Standard Specifications Waterworks Construction:**Section 503.01.00 (15) and Sheet 61A Updates**

The City of Calgary is updating Section 503.01.00 (15) 'Service Line Couplings' and Sheet 61A: '50mm Flushing Assembly Type 'A'' in the 2025 Standard Specifications Waterworks Construction. The update provides new materials better suited for underground construction to ensure longevity and safety for operators.

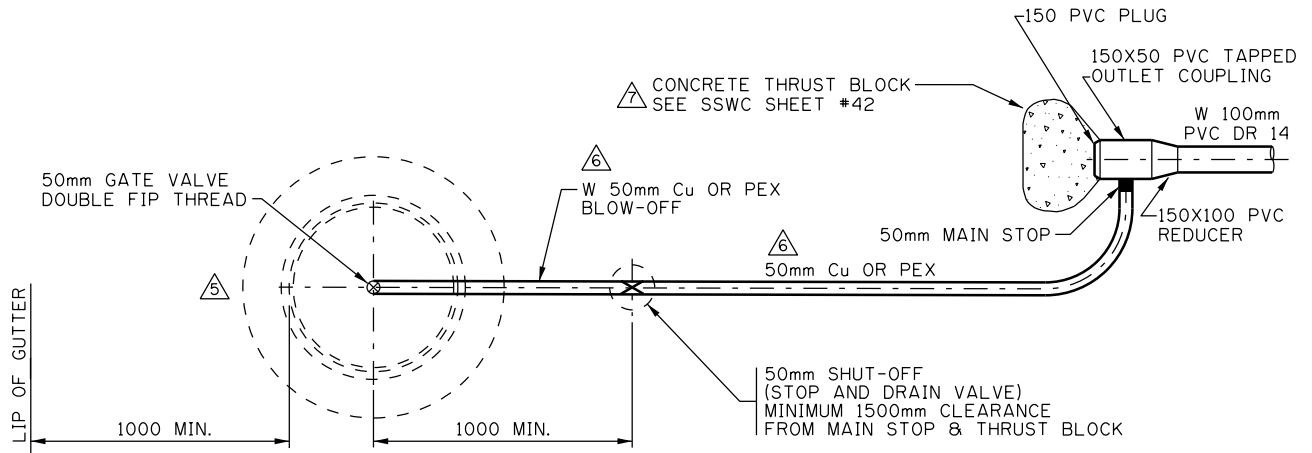
The approved product list in Section 503.01.00 (15) will now include a new style of 'Restrained Coupling'. The current clause in Section 503.01.01:

is replaced with:

“(15) Service Line Couplings**Inline Couplings:**

Manufacturers as listed for Main Stops and Service Valves

Restrained Couplings:

Pack Joint by Mueller

Lead-Pak by Ford

CAMPAK by Cambridge Brass

or approved equal”

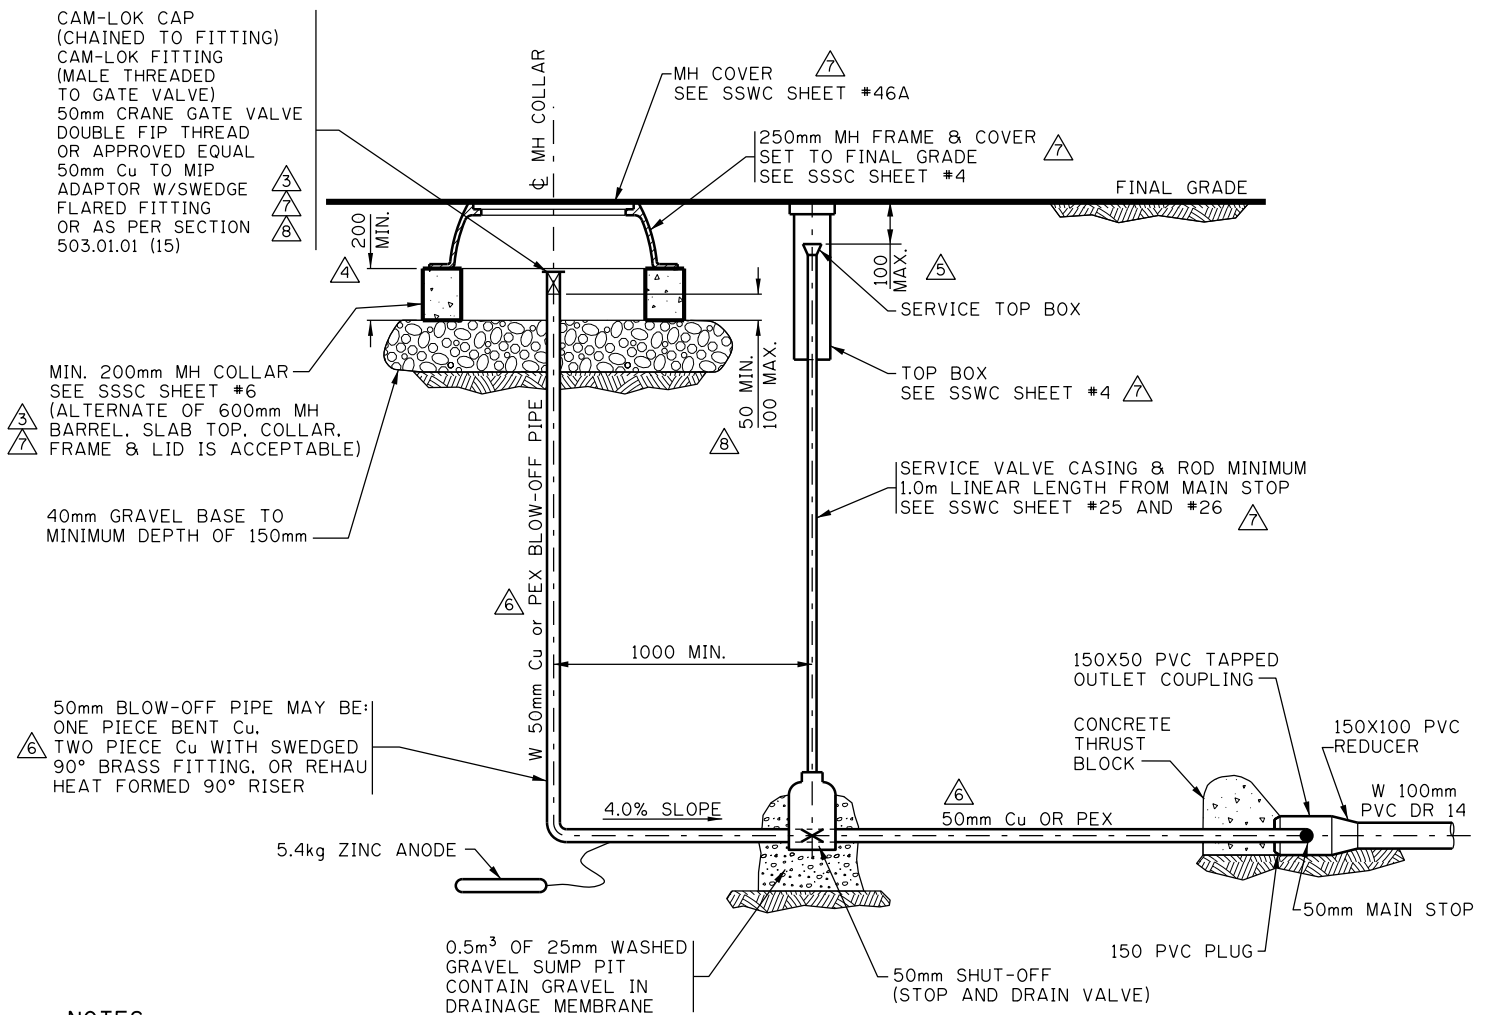
The current **Sheet 61A** is ***Removed and Replaced*** with the attached version. The update removes the 'Sharkbite' style coupling and references the new 'Restrained Coupling' approvals in Section 503.01.00 (15). It also sets a minimum and maximum limit that service pipe may extend above ground. Revisions are listed as #8 on the attached page.
